SERVICE INFORMATION

Number: 210-1704 UTG. 2

Addendum to the service programme "Retightening of cylinder head bolts"

Model year 1994 and later Saab 900 cars with 4-cylinder engine

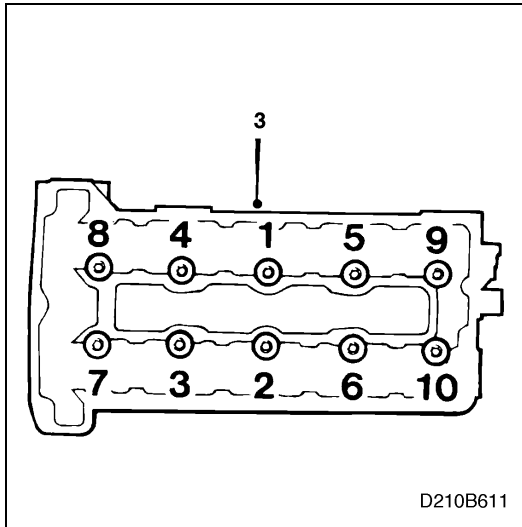
The tightening torque for the cylinder head bolts has been changed.

- 3 Back off bolt number 1 and tighten it again. Repeat this in the order shown. Tightening torque 40 Nm (30 lbf ft).

- 4 Tighten bolt number 1 to a torque of 60 Nm (44 lbf ft). Tighten the other bolts to the same torque in the order shown, see illustration.
- 5 Tighten bolt number 1 an additional 90 (1/4 turn). Tighten the other bolts similarly in the order shown, see illustration.
- 6 Tighten the timing cover retaining bolts. Tightening torque 22 Nm (16 lbf ft).

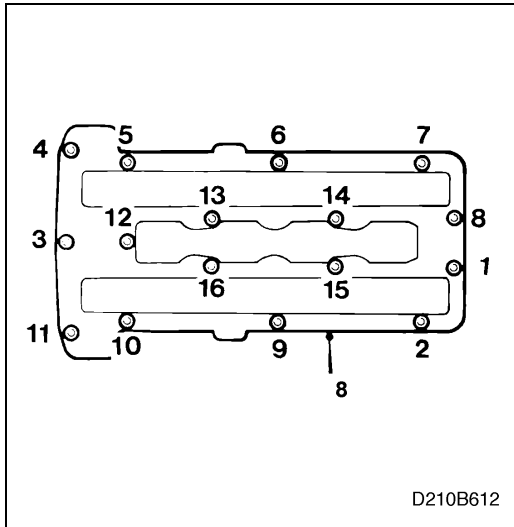
- 8 Fit the camshaft cover, starting by tightening the two bolts at the opening, see figure. Continue with the bolt situated in the middle of the transmission end and proceed round the outer perimeter of the camshaft cover. Finish by tightening the bolts round the inner perimeter. Tightening torque 15 Nm (11 lbf ft).
- 9 Fit the ignition discharge module or cover over the spark plugs. Tightening torque 11 Nm (8 lbf ft).
